SHINE MEDICAL TECHNOLOGIES, INC.

SHINE MEDICAL TECHNOLOGIES, INC. APPLICATION FOR CONSTRUCTION PERMIT RESPONSE TO REQUEST FOR ADDITIONAL INFORMATION

Figure 12.1-1-1. SHINE Operational Organization Chart

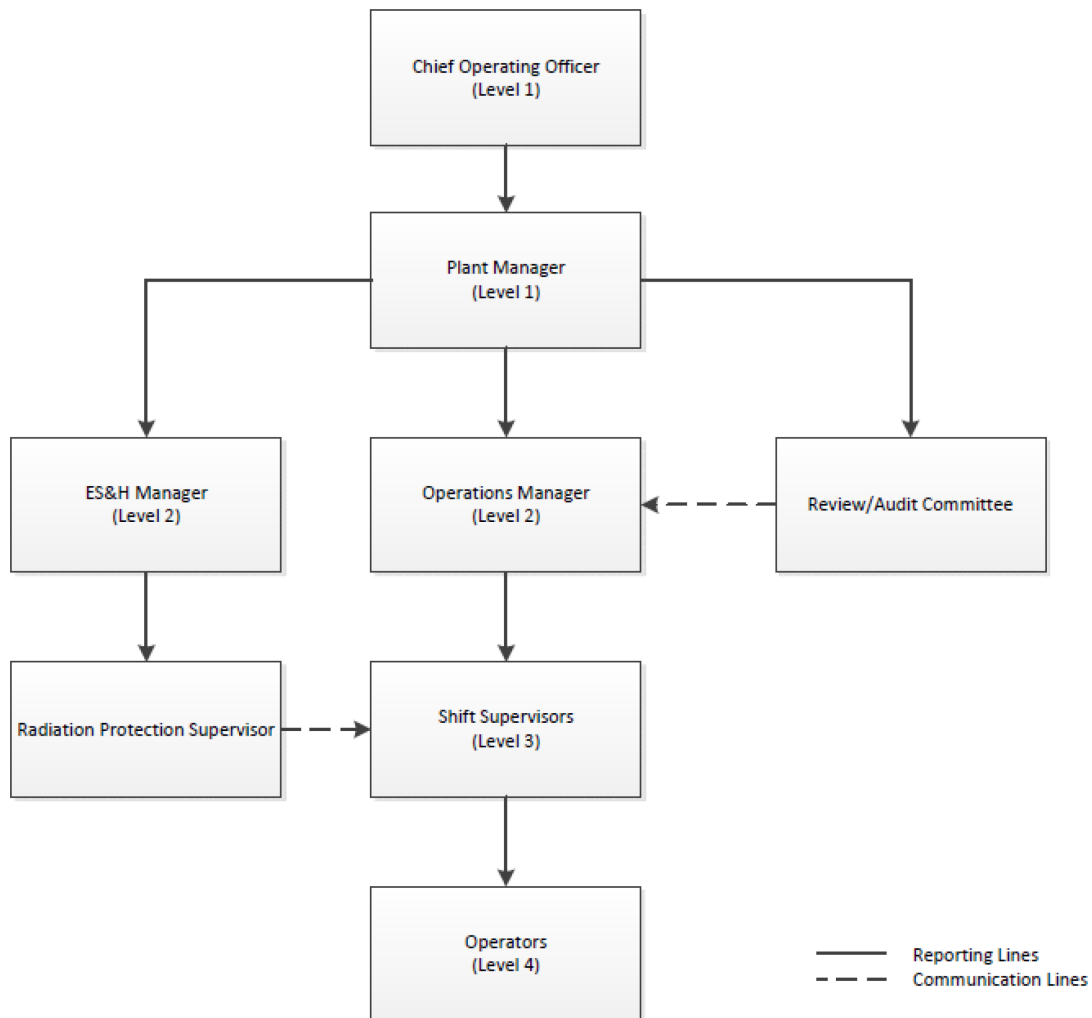
The SHINE PSAR provides the functional organization in Figure 12.1-1 (ADAMS Accession No. ML13172A304), and PSAR, Section 12.1, “Structure,” states, in part: “The staff implementing the radiation safety function supports on-shift plant operations and interacts with Executive Management through the chain of command.” However, the organization chart does not include the review and audit function or the radiation safety function.

- a) In accordance with Section 6.2.1 of ANSI/ANS-15.1-2007 (Reference 18), the SHINE Review and Audit Committee will report to the Plant Manager (Level 1 management). In accordance with Section 6.3 of ANSI/ANS-15.1-2007, the SHINE radiation safety function (Radiation Protection Supervisor) will report to the Environmental Safety and Health (ES&H) Manager (Level 2 management). The reporting and communication lines of the SHINE Review and Audit Committee and the Radiation Protection Supervisor are provided in Figure 12.1-1-1.

SHINE will update Subsection 12.1.2 in the FSAR to provide a description of the SHINE management levels, in accordance with Section 6.1.1 of ANSI/ANS-15.1-2007. SHINE will also update Figure 12.1-1 in the FSAR to include the SHINE Review and Audit Committee and the Radiation Protection Supervisor in the SHINE organizational chart. An IMR has been initiated to track the update to Subsection 12.1.2 and Figure 12.1-1.

Figure 19.2-4-1: Conceptual Rendering of the SHINE Facility

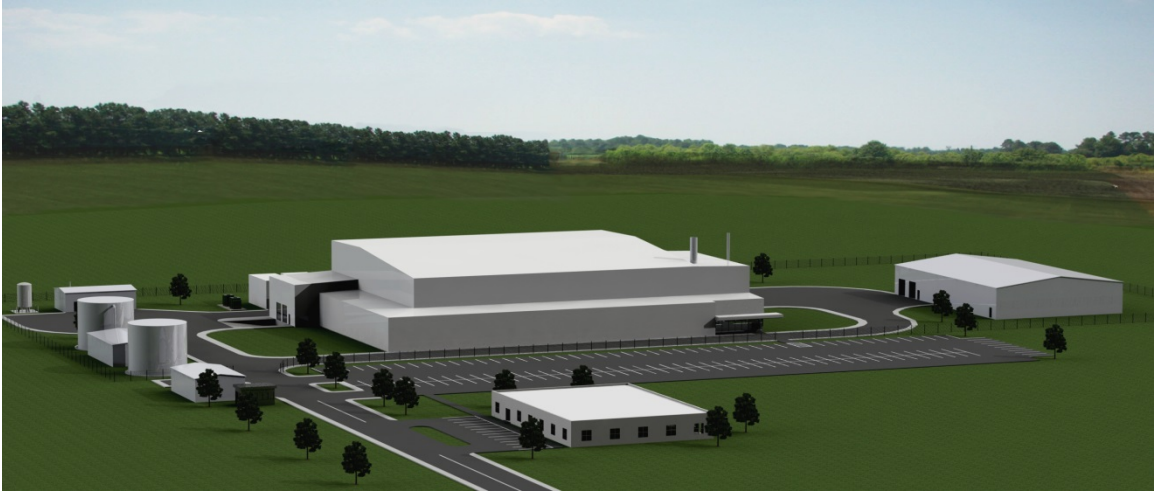
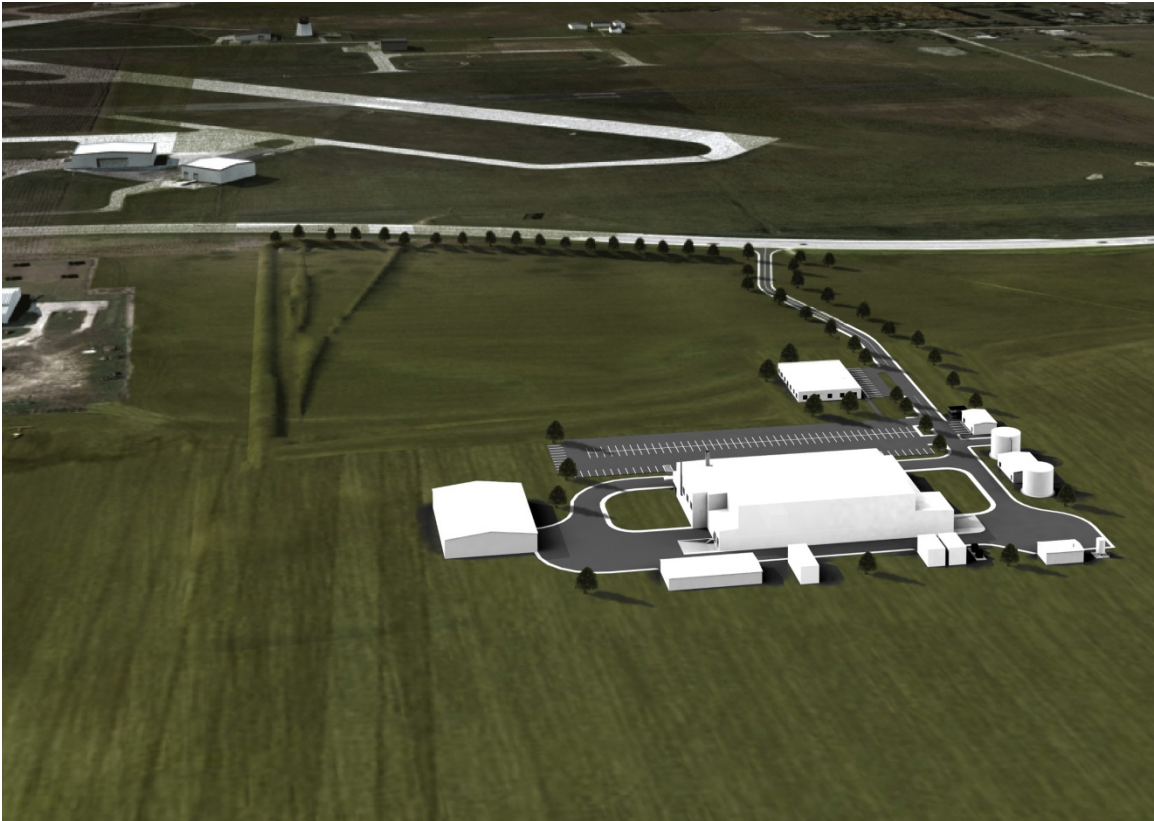
- d) *Facility Layout: Figure 19.4.1-1 in the SHINE ER presents a conceptual illustration of the proposed SHINE facility. However, the relative orientation of the facility buildings presented in Figure 19.4.1-1 are not consistent with building locations presented in SHINE ER Figures 19.2.1-1 and 19.4.1-2.*

The facility bounding dimensions provided in Subsection 19.4.1.2 of the PSAR and used in the visual impact assessment were based on an earlier facility design, and are not current. Additionally, the conceptual renderings of the SHINE facility provided in Figure 19.4.1-1 of the PSAR were based on an earlier facility design, and are not current. An IMR has been initiated to address the issue.

Revised conceptual renderings of the SHINE facility, superseding those provided in Figure 19.4.1-1 of the PSAR, are provided in Figure 19.2-4-1. Based upon the site characteristics described in Subsection 19.4.1.2 of the PSAR, and the dimensions of the current SHINE facility design as illustrated in Figure 19.2-4-1, facility structures have a relatively low profile, so any impacts to the viewshed remain SMALL.

- d) As described in Part a of this response, the conceptual renderings of the SHINE facility provided in Figure 19.4.1-1 of the PSAR were based on an earlier facility design, and are not current. Revised conceptual renderings of the SHINE facility, superseding those provided in Figure 19.4.1-1 of the PSAR, are provided in Figure 19.2-4-1.

The revised conceptual renderings provided in Figure 19.2-4-1 are consistent with the building and area locations described in Figures 19.2.1-1 and 19.4.1-2 of the PSAR.
